*Environmental
Planning
Commission*

*Agenda Number: 6
Project #: PR-2023-009178
VA-2023-00246
Hearing Date: November 16, 2023*

Staff Report

Agent	Self-Represented
Applicant	Frank J. and Clarissa J. Gonzales
Request	Variance - EPC
Legal Description	All or a portion of Lot 21, Block 1, Unit 27, Volcano Cliffs
Location	5505 Valiente Rd NW, between Calle Norteña NW and the Piedras Marcadas Major Public Open Space (MPOS)
Size	Approximately 0.4 acres
Existing Zoning	R-1D

West Elevation (looking eastward)

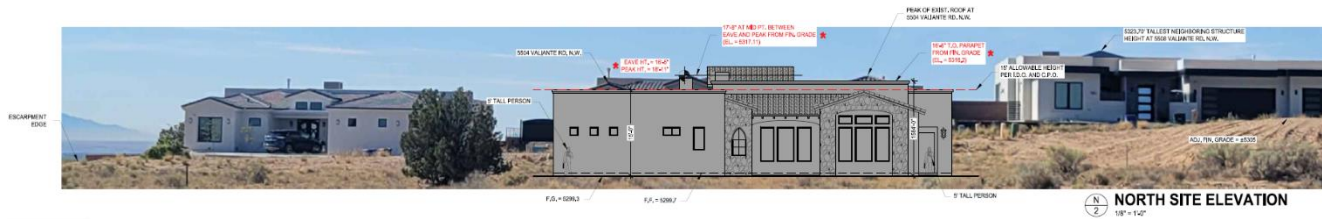
The West Elevation of the proposed structure demonstrates the eastward views and the west face of the building. The Petroglyph Monument Park escarpment edge is visible in the distance to either side of the proposed structure. From this direction, over half of the length of the proposed home is at or below the IDO allowable height of 15-feet tall. The highest point of the structure is 18 feet 11 inches with almost a quarter of its length at 16 feet 5 inches or taller than the finished pad. Since the highest portion (18 feet 11 inches) of the house is oriented east-west, the tallest portion of the structure is a gabled peak that minimally impacts views. The structure outline remains below the ridge line of the Sandia Mountains and leaves the view to this feature relatively unobstructed.

East-West Site Section (North/South): View to the North

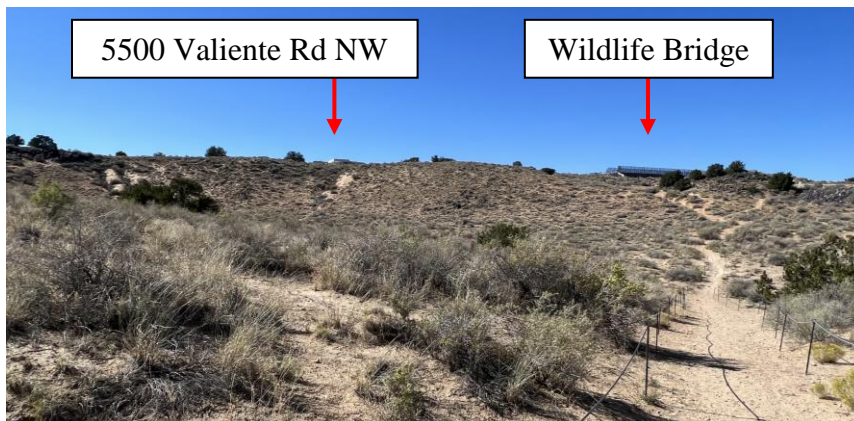
Although the vertical scale is unclear in the provided section, the proposed project should allow typical views east toward the Northwest Mesa Major

Public Open Space escarpment with the presence of a structure. Standing below the escarpment to the east at the Cumberland Rd NW cul-de-sac, the existing home at 5500 is not distinguishable from the trees on the horizon; the wildlife bridge that passes over Paseo del Norte Blvd NW is. The proposed structure would be set further back from the ridge top and would probably remain invisible from below.

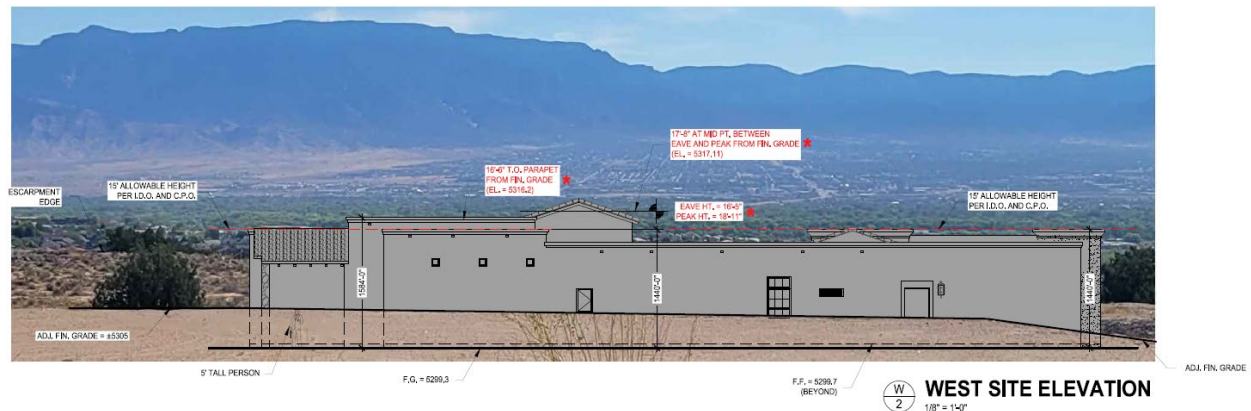
Although the proposed West Elevation does not appear to obscure the the Sandia Mountains, the purpose of the VPO-2 height restrictions is to preserve the views to and from the escarpment. A building, regardless of height will restrict views by the fact that there is a solid mass in place of a previously open space with natural features. The applicant has provided evidence that the proposed development will have a marginally greater visual impact than if the 15-foot height limit were met. Site plans, site
